## Application for Licence Amendment

<b>Choose an item.</b>	L7276/1996/12
<b>Licence Holder</b>	Murrin Murrin Operations Pty Ltd
<b>ACN</b>	076 717 505
<b>File Number</b>	2011/011705-1
<b>Premises</b>	<p>Murrin Murrin Nickel Cobalt Project</p> <p>Mining tenements, L39/81, L39/62, L39/83, L39/136, L39/168, M39/314, M39/322, M39/562, M39/637, M39/686, M39/692, M39/714, M39/715, M39/716, M39/737, M39/299, M39/651, M39/300, M39/301, M39/435, M39/436, M39/421, M39/422, M39/423, M39/424, M39/342, M39/343, M39/446, M39/820</p> <p>LAVERTON WA 6440</p> <p>As defined by the Premises maps attached to the Revised Licence</p>
<b>Date of Report</b>	2 December 2021
<b>Decision</b>	Revised licence granted

**Figure 1: Plant site monitoring bores**

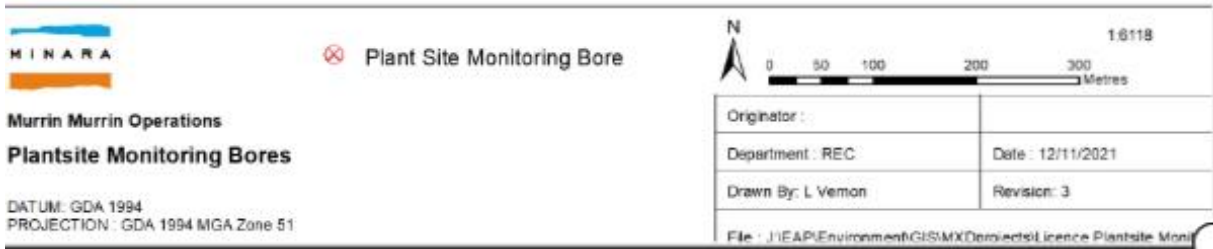
The Licence Holder proposes, as part of this amendment, to remove a plant site monitoring bore (PSMB17D) and in-pit monitoring bore (IP804-4) from the groundwater monitoring schedule detailed in Table 3.5.1 of L7276/1996/12.

PSMB17D was destroyed when there was a recent increase in sulfur storage on the premises. Mining operations at Murrin Murrin will soon advance to the 806 pit, within which IP804-4 is located. Once operations in this area reach blasting stage, IP804-4 will be destroyed.

With the destruction of PSMB17D the plant site monitoring network is maintained through PSMB7D, PSMB9D and PSMB11D to the north, east and south (plant site network) (see Figure 1), and in-pit monitoring bores to the west (IP902-3, IP902-4, and IP902-5). The Delegated Officer notes that the in-pit monitoring bores have the same reporting parameters (standing water level, pH, total dissolved solids (TDS)) as the plant site bores, but don't have a nickel target <1 mg/L set.
